DOWNTOWN WEST SUBDIVISION, UNIT 2

RESUBDIVISION OF LOTS 7 & 8

APPLICATION NUMBER 3 DATE June 18, 2015
 APPLICANT Downtown West Subdivision, Unit 2, A Resubdivision of Lots 7 & 8
 REQUEST Subdivision

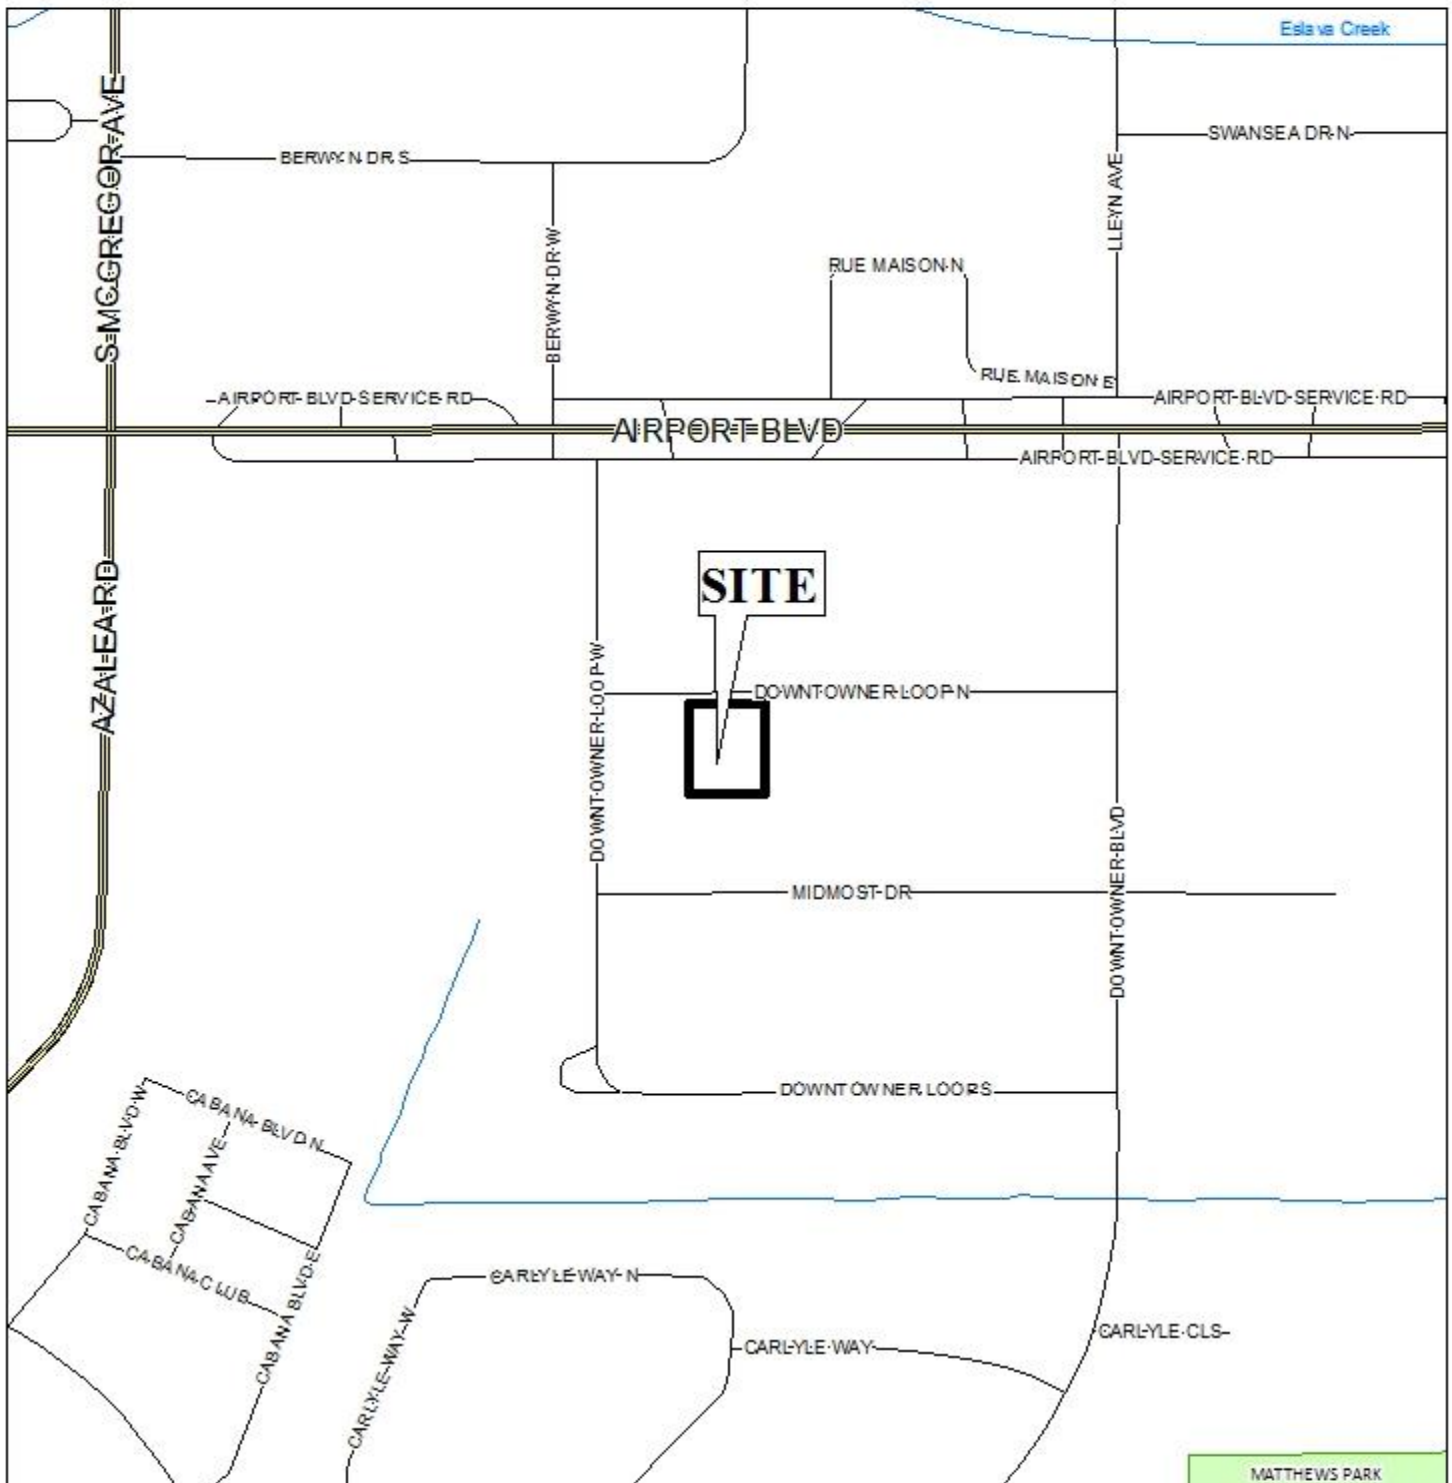
The site has two curb cuts, one of which is currently shared between each lot. Combining these lots increases the proposed lot width to 199'±, therefore this site should be limited to the existing number of curb cuts, with any changes in their size, design, and location to be approved by Traffic Engineering and conform to AASHTO standards.

The proposed lot meets the minimum area and width requirements of the Subdivision Regulations. The plat should be revised to label the lot with its size in both square feet and acres or a table should be furnished on the Final Plat providing the same information. The plat should also be revised to illustrate the 25' minimum building setback line along Downtowner Loop North.

- 1) placement of a note on the Final Plat stating that the Lot is limited to its existing curb cuts, with any changes in size, location, or design to be approved by Traffic Engineering and conform to AASHTO standards;

- 2) revision of the plat to label each lot with its size in both square feet and acres, after any required dedication, or the furnishing of a table on the Final Plat providing the same information;

- 3) revision of the plat to illustrate the 25' minimum building setback line along Downtowner Loop North;
- 4) compliance with Engineering comments: (A. *Any work performed in the existing ROW (right-of-way) such as driveways, sidewalks, utility connections, grading, drainage, irrigation, or landscaping will require a ROW permit from the City of Mobile Engineering Department (208-6070) and must comply with the City of Mobile Right-of-Way Construction and Administration Ordinance (Mobile City Code, Chapter 57, Article VIII). Application and/or questions can be sent to rightofway.permits@cityofmobile.org.* B. *A Land Disturbance Permit application shall be submitted for any proposed land disturbing activity with the property. A complete set of construction plans including, but not limited to, drainage, utilities, grading, storm water detention systems, paving, and all*
